Access Compliance Report

Public Rights-of-Way

Intersection ID: 7240	Main Street: MONTEITH_DR	Cross Street: TOM_HUNTER_RD	Location: SE
ADA ID: E486266B1E0D	Ramp Type: Perp	Initial Pass/Fail: Fail	Overall Compliance: No
Severity Score: 13.75			
Codes/Mitigation Info/Possible Solution		Field Measurements/Component Compliance

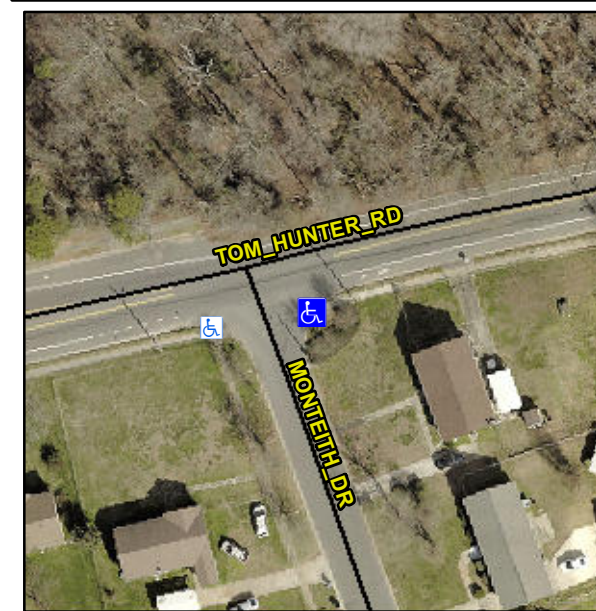
Not Found, R304.2.2, R304.5.3

Compliance	Description	Data	Compliance	Description	Data
N/A	Ramp Length (in)	59.5	No	Ramp Slope (%)	10.3
Yes	Ramp Width (in)	48.0	No	Ramp XSlope (%)	3.2
N/A	Flare Type LT	N/A	N/A	Flare Type RT	N/A
N/A	Flare Slope LT (%)	N/A	N/A	Flare Slope RT (%)	N/A
N/A	Flare Traversable LT?	N/A	N/A	Flare Traversable RT?	N/A
N/A	Landing Length (in)	N/A	N/A	DWS Provided?	N/A
N/A	Landing Width (in)	N/A	N/A	DWS Contrast?	N/A
N/A	Landing Slope (%)	N/A	N/A	DWS Length (in)	N/A
N/A	Landing X Slope (%)	N/A	N/A	DWS Full Width?	N/A
N/A	Landing Curb? (Y/N)	N/A	N/A	DWS Offset (in)	N/A
N/A	Shared Landing?	N/A			
N/A	Gutter Ponding?	N/A	N/A	Gutter Slope (%)	N/A
N/A	Gutter Lip Ht (in)	N/A	N/A	Gutter X Slope (%)	N/A
N/A	Painted X Walk1?	No	N/A	Painted X Walk2?	N/A
	X Walk 1 Direction	To W		X Walk 2 Direction	N/A
N/A	X Walk 1 Width (in)	N/A	N/A	X Walk 2 Width (in)	N/A
	X Walk 1 Slope (%)	3.3		X Walk 2 Slope (%)	N/A
	X Walk 1 X Slope (%)	0.5		X Walk 2 X Slope (%)	N/A

Remove & Replace Entire Ramp.
